SERVICE LETTER 199

Main Pylon Attach Point Fuselage Bracket

Aircraft Makes/Model(s):	Float Model(s):	Compliance: Optional	By: MAB
AT-802 & AT-802A	10000A	Part Number: 1011061	Approved: SDW
		Date: 1/21/2022	Revision: D

Figure 1

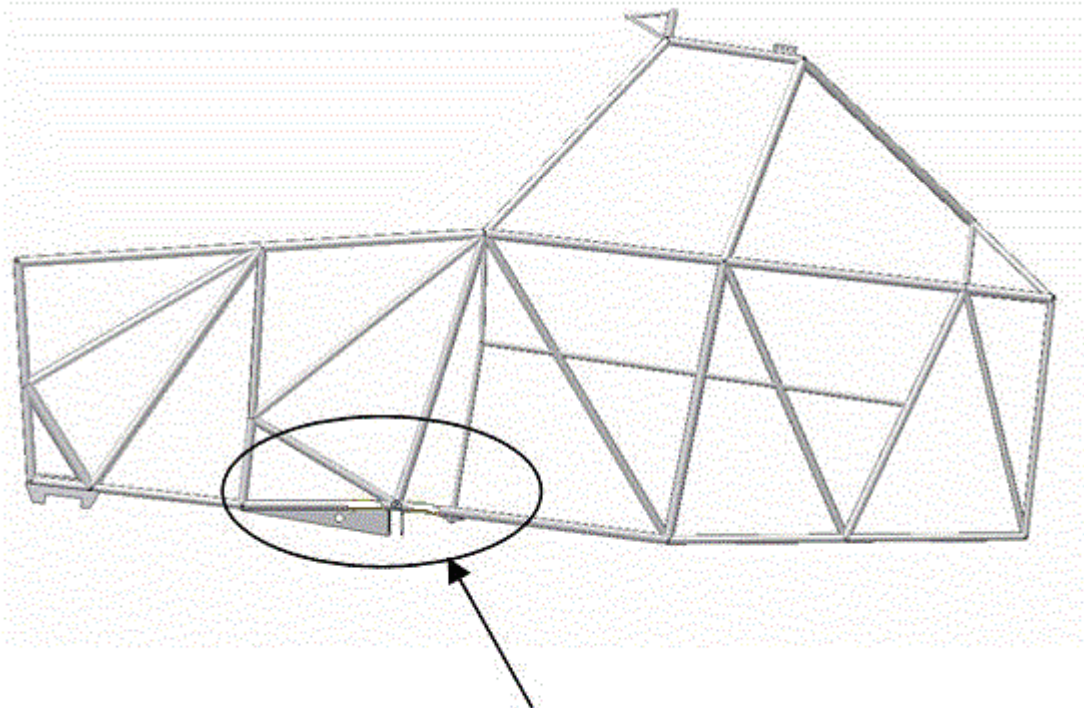
1. Visually inspect lower longeron tube (Figure 1) and the entire nearby welded tube cluster for signs of cracking on both sides of the aircraft. Pay special attention to areas A and B on Figure 2. If there is doubt about crack presence, strip paint from tubes for visual inspection and consider magnetic particle, dye penetrant, or eddy current inspection.
2. If cracks are found, repair cracks per AC 43.13-1B and Wipaire Service Letter 71 before accomplishing the work instruction of this service letter. If cracks are not found installation of the gussets per the work instruction of this service letter is recommended but not required.

Figure 2

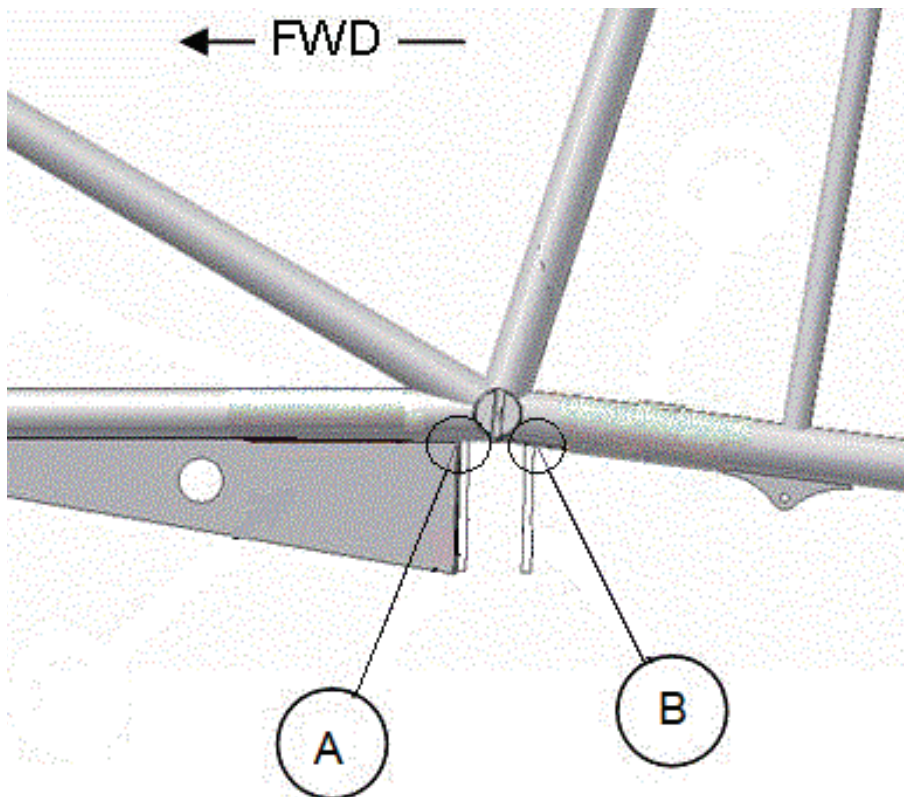
8. If cracks are present, groove cracks (Figure 2, areas A and B) and re-weld.
9. Depending the shape of the existing brackets, the new gussets may require grinding to fit. Groove new gussets and existing brackets as required for weld penetration.

Airframe After Repair

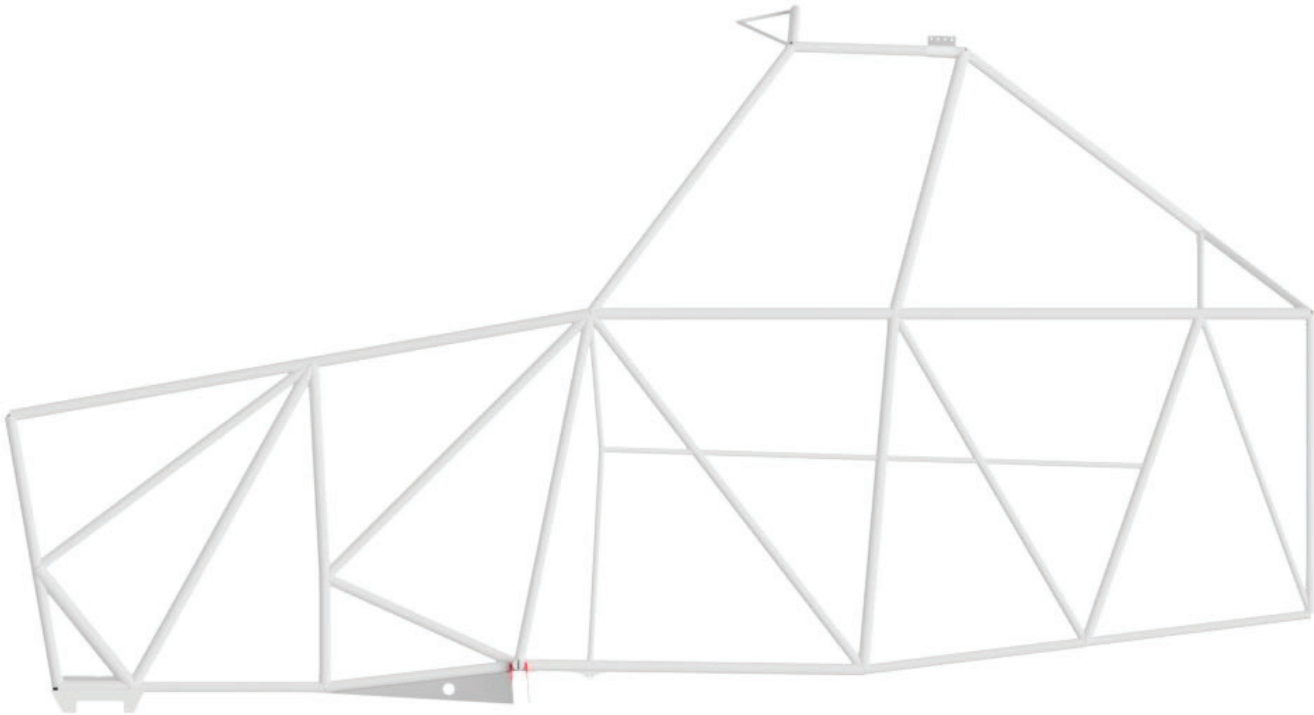
10. Fully weld the gussets in place; GTAW with ER70S-2, ER70S-6 or ER80S-D2 filler and 100%Ar shielding gas or other approved method. Weld to be visually free of irregularities, cracks, craters, undercuts, and lack of fusion.

11. Stress-relieve areas ends of the added gussets; heat slowly with oxy-fuel torch until surrounding metal just starts to turn red, 1550°F. Alternately stress relief may be accomplished at a lower temperature; heat gradually to 1200°F using a 1200°F Tempilstick (Markal) or equivalent method. Allow to cool gradually in still air.
